**RE: 833 South 800 East Rezone and Master Plan Amendment
PLNPCM2019-01111**

**RE: 833 South 800 East Rezone and Master Plan Amendment
PLNPCM2019-01111**

Re: PLNPCM2019-01110 – Master Plan Amendment
PLNPCM2019-01111 – Zoning Map Amendment
PLNSUB2019-01112 – Telegraph Exchange Lofts Planned Development

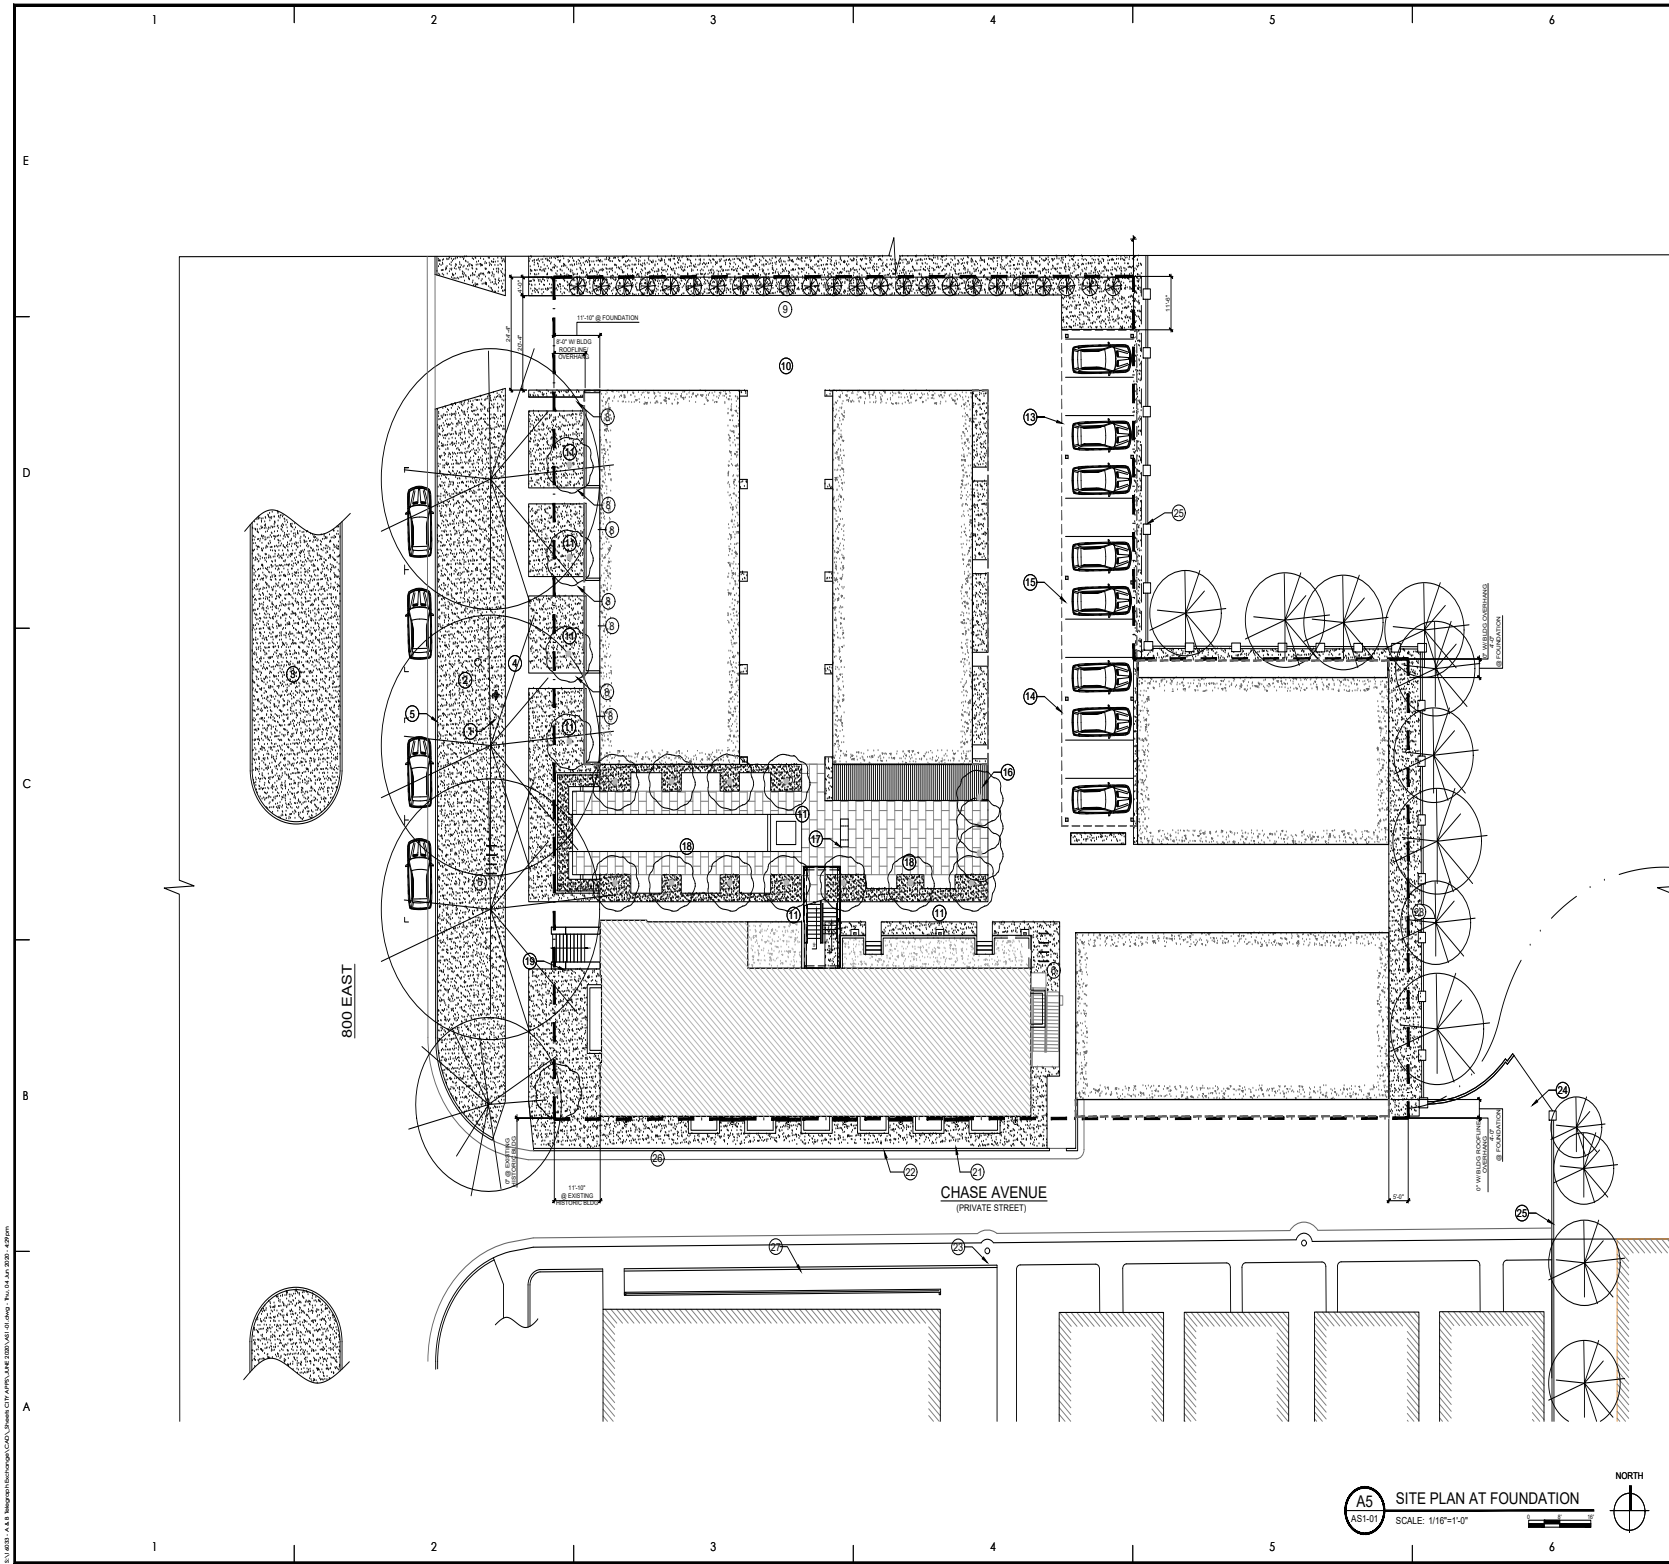
The Architectural Site Plan, sheet AS1-01, shows new sidewalk to be installed on the south side of Chase Avenue. SLC Engineering has no objection to this but since Chase Avenue is a private street, consent of the property owners who have rights to Chase Avenue must be obtained prior to installation of the sidewalk.

AS1-01

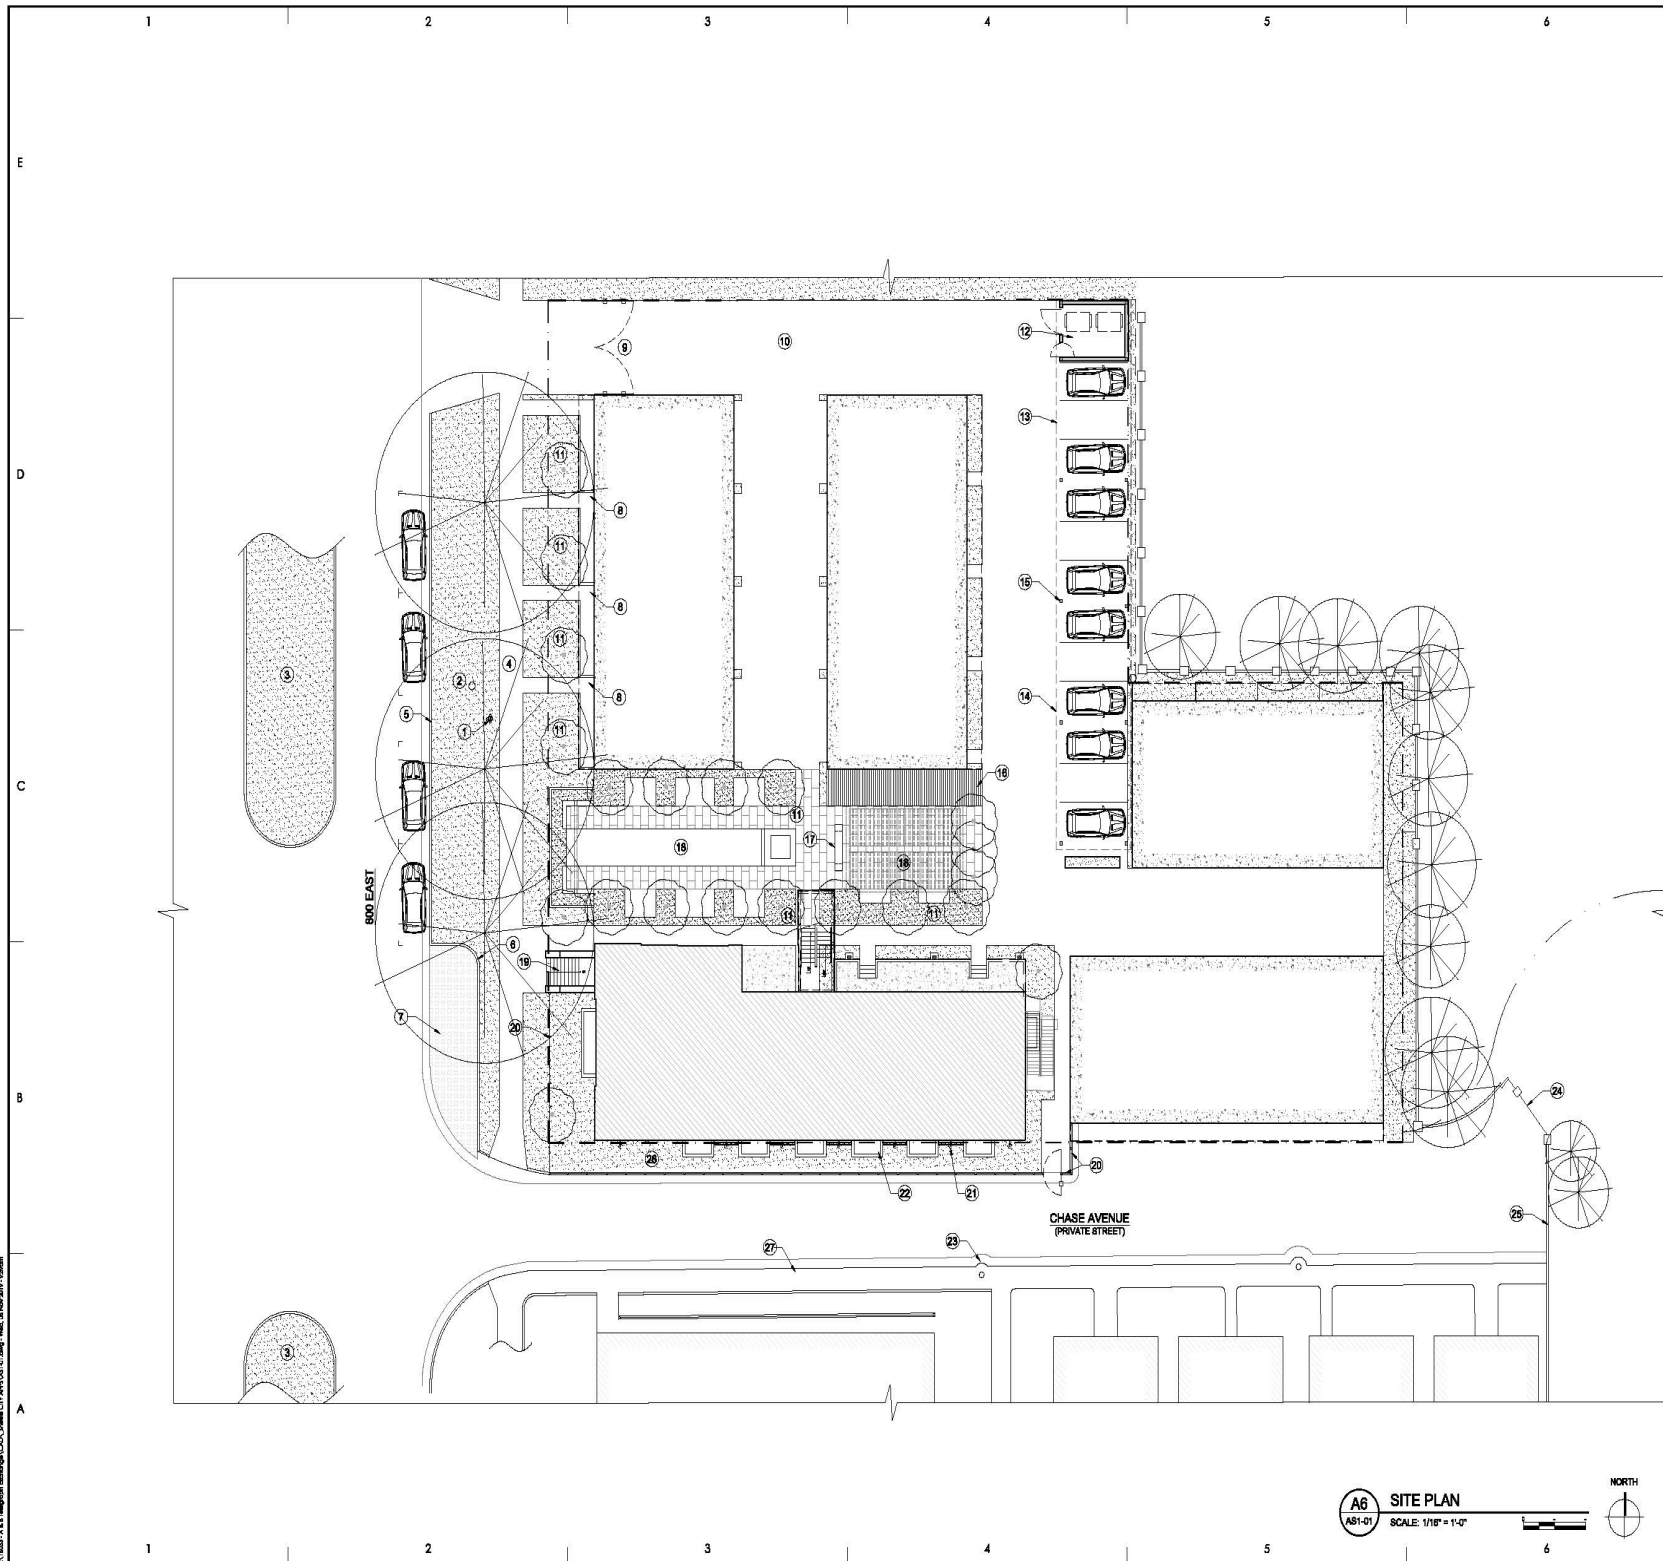
The Architectural Site Plan, sheet AS1-01, shows new sidewalk to be installed on the south side of Chase Avenue. SLC Engineering has no objection to this but since Chase Avenue is a private street, consent of the property owners who have rights to Chase Avenue must be obtained prior to installation of the sidewalk.
